ISO/PAS 8329

Description of mechanical connections
and joints in structural systems

ISO/PAS 8329 xMCF WG meeting
focus group on issues [#95](#) / [#104](#)
2026-10-02

Figure 52 — Welding position of a Y-joint

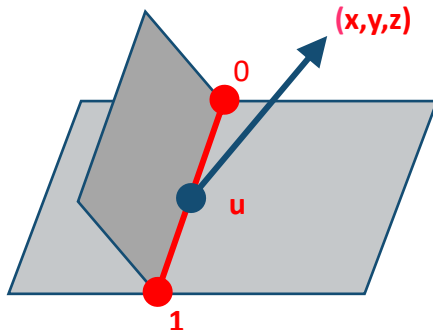
This does *not* tell us how to handle *more than one* <loc_list/>.

Q1: The foot point of <weld-position/>-direction is

$$a + u * (|b - a| + |c - b|) * \frac{b - a}{|b - a|} = (2581.296, -708.387, 33.138)$$

which is roughly in the middle between *a* and *b*.

— If we consider the first section, only! But what about *|e - d|*?

- Decision: We treat the set of all polylines as if it was continuous. Then, <weld_position/> can be propagated from one polyline to the next one. And for the definition of parameter “u”, all polyline lengths are summed up. ⇒ This answers Q2 & Q1.
- Decision criterion: If the robot *cannot* weld a line in one run, it must be split in two <connection_1d/> (and not in two <loc_list/>).
- This implies that gaps between adjacent <loc_list/> must not be too big.
- Recommendation for max. gap size:
10 × geometric tolerance of the software system.
Here, “geometric tolerance” refers to the maximum distance between two coordinates for them to be considered numerically coincident.

$$a + u * (|b - a| + |c - b| + |e - d|) * \frac{b-a}{|b-a|},$$

where u is such small that the foot point lies within
<loc_list index="1">

- This decision needs to be documented in the specification.
The [issue #117](#) has been created for this.

Figure 53 — Welding position vector direction and length

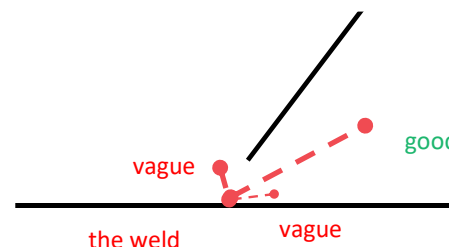
Q2: The <weld-position/>-direction should be maintained continuously along the weld line. But what if the weld line is interrupted?

What if the situation at the 2nd <loc_list/> is like this?

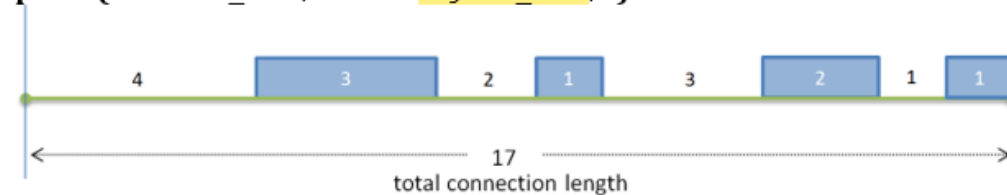
Would it be a good idea to add an explanation in case intermittent conn-lines are used in conjunction with multiple `<loc_list/>`?

It appears at least not to be trivial how the `from` and `to` parameters are to be handled in the vicinity of gaps ...

The suggestion “add explanation” was confirmed, e. g. in the following sense:

The strategy to handle multiple polylines as “one continuous geometrical entity” applies here, too.

Thus, the parameters “`from`” and “`to`” refer to the total length of all polylines. (The final wording has yet to be found.)

The [issue #118](#) has been created for adding this explanation.
